# Populating PR20 PMD Tables

John Johnson, Broadcom Inc.

#### PR20 PMD Progress

## **May 2018 Motion #9**

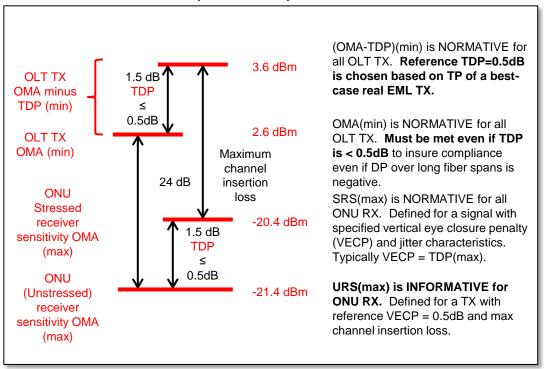
Table 141-7—OLT PR20 Transmit Characteristics, 25GBASE-PR20-D, Average launch power, each channel (min) = 2.5 dBm. 2.0 dBm

Table 141-7—OLT PR20 Transmit Characteristics, 25GBASE-PR20-D, Extinction ratio (min) = 8 dB. Table 141–9—OLT PR20 Receive Characteristics, 25GBASE-PR20-D, Receiver sensitivity (OMA), each channel (max) = -22 dBm

Table 141–11—ONU PR20 Transmit Characteristics, 25GBASE-PR20-U, Average launch power, each channel (min) = 4 dBm

Table 141–11—ONU PR20 Transmit Characteristics, 25GBASE-PR20-U, Extinction ratio (min) = 3.5 dB

Table 141–13—ONU PR20 Receive Characteristics, 25GBASE-PR20-U, Receiver sensitivity (OMA),

each channel (max) =  $\frac{23 \text{ dBm}}{100}$ . -23.5 dBm

Values in red represent the corrections in harstead\_3ca\_1\_0718.pdf.

#### PR20 DS OMA vs. TDP (VECP)

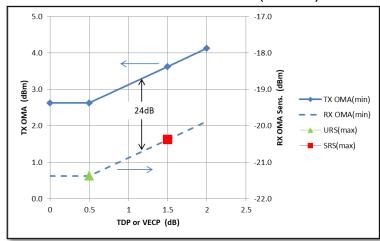
- OLT TX OMA(min) depends on TDP
  - TX with TDP ≤ 0.5dB only needs 2.6dBm
  - Worst case TX (TDP = 1.5dB) must launch 3.6 dBm
- Assumes real-world EML TX have TP
   ≥ 0.5dB
  - All OLT TX must launch OMA ≥ 2.6dBm
  - URS OMA(max) = -21.4dBm at VECP = 0.5dB
- Stressed ONU receiver sensitivity is defined for worst case TX with VECP = 2dB
  - SRS OMA(max) = -20.4dBm

#### PR20 DS power budget - expanded

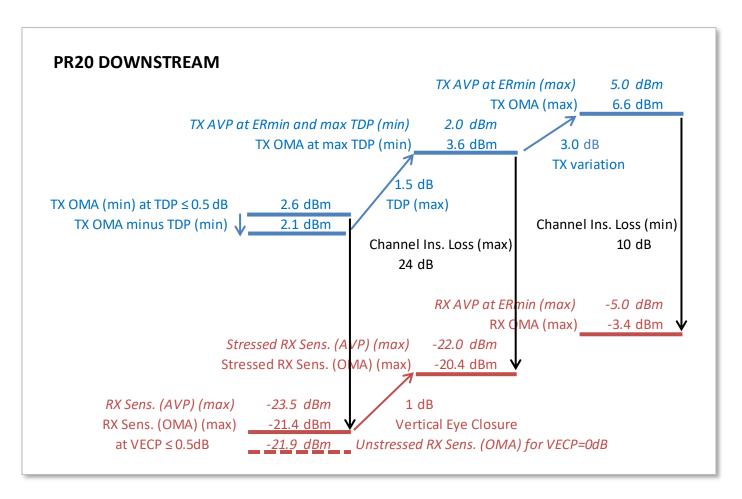
The values from May Motion #9 as corrected in harstead\_3ca\_1\_0718 are converted to the OMA minus TDP spec method in the same was as was done for PR30 downstream in johnson\_3ca\_1\_0518.

## OLT TX AVP, OMA and ER

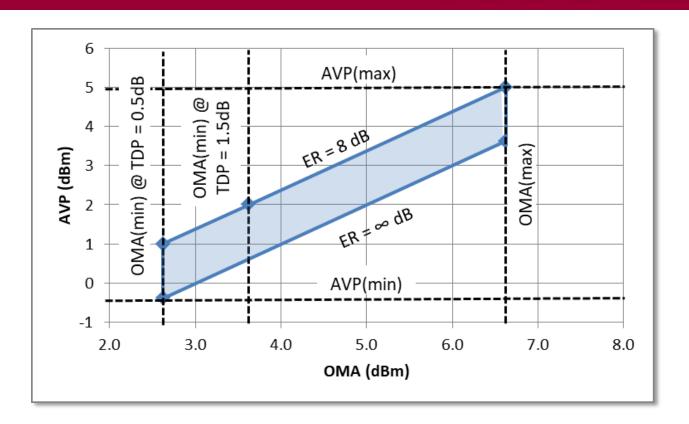
- The foregoing analysis uses OMA at the minimum extinction ratio ER = 8 dB.
- Maximum Average Power (AVP) is proposed based on ER = 8dB at the value of maximum OMA, giving 5.0 dBm maximum.
- All OLT TX must have both OMA > 2.6 dBm and AVP > 0.5 dBm.

#### PR20 US OMA vs. TDP (VECP)

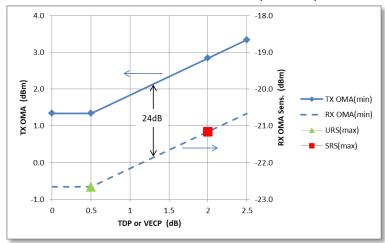
- ONU TX OMA(min) depends on TDP
  - TX with TDP ≤ 0.5dB only needs 1.3dBm
  - Worst case TX (TDP = 2dB) must launch
     2.8 dBm
- Assumes real-world DML TX have TP
   ≥ 0.5dB
  - All ONU TX must launch OMA ≥ 1.3dBm.
  - URS OMA(max) = -22.7dBm at VECP = 0.5dB
- Stressed OLT receiver sensitivity is defined for worst case TX with VECP = 2dB
  - SRS OMA(max) = -21.2dBm

#### PR30 US power budget - expanded

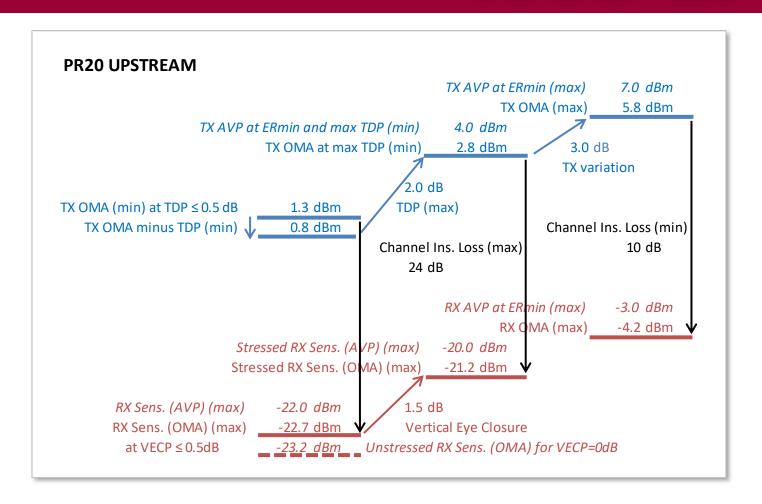
The values from May Motion #9 are converted to the OMA minus TDP spec method in the same was as was done for PR30 upstream in johnson\_3ca\_1\_0518.

## ONU TX AVP, OMA and ER

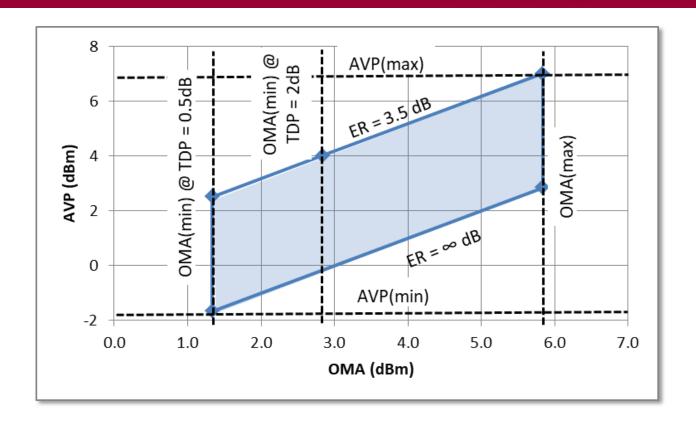
- The foregoing analysis uses OMA at the minimum extinction ratio ER = 3.5 dB.
- Maximum Average Power (AVP) is proposed based on ER = 3.5 dB at the value of maximum OMA, giving 7 dBm maximum.
- All ONU TX must have both OMA > 1.3 dBm and AVP > -0.8 dBm.
